Change Notice

GB & GW Series

Changes to Location & Production for GB Pushbuttons & GW Rockers & Paddles

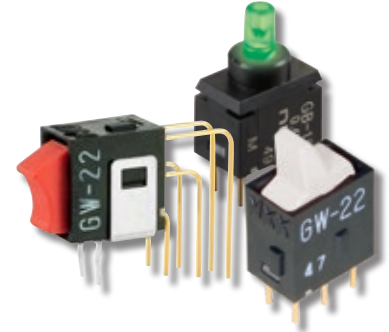
There will be revisions to the production and manufacture location for GB Pushbuttons and GW Rockers and Paddles, both illuminated and nonilluminated in each series. Previously, the lot code on the switch body had a dot mark above the first digit, but now the dot mark will be above the second digit. The shipping box for these pushbuttons, rockers or paddles had "CHINA FACTORY" on the side, but will be replaced with "PHILIPPINES FACTORY."

Lot Number	Shipping Box
Before Changes	Dot Mark Above First Digit  Enlarged to Show Detail	 "CHINA FACTORY" printed on side of box
After Changes	Dot Mark Above Second Digit  Enlarged to Show Detail	 "PHILIPPINES FACTORY" printed on side of box
